## MESH2-Ø16/20 Change Notification

MESH2-Ø16/ Ø20

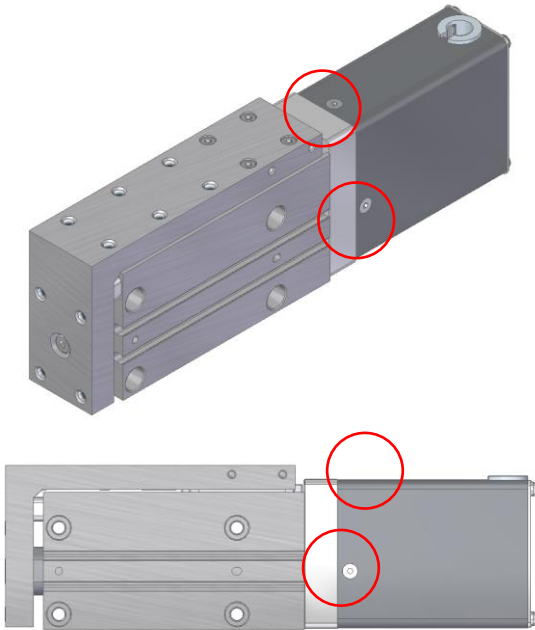
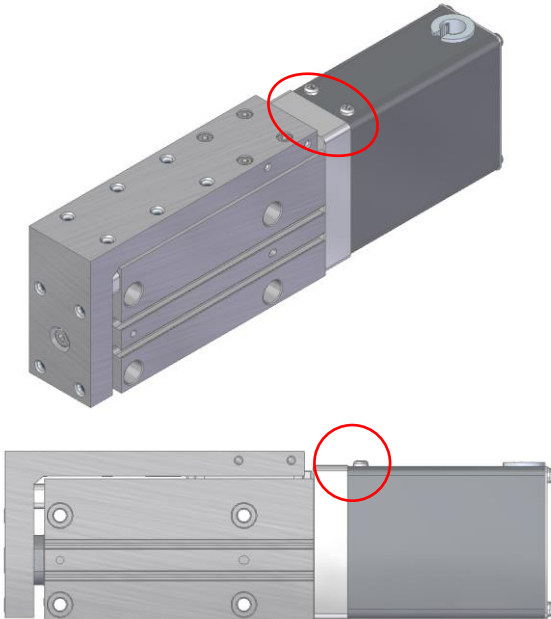
Change holes and bolts due to process changes.

Before	After
<p>Use Countersunk Screw Flat Head</p> 	<p>Use Phillips round head screws</p>
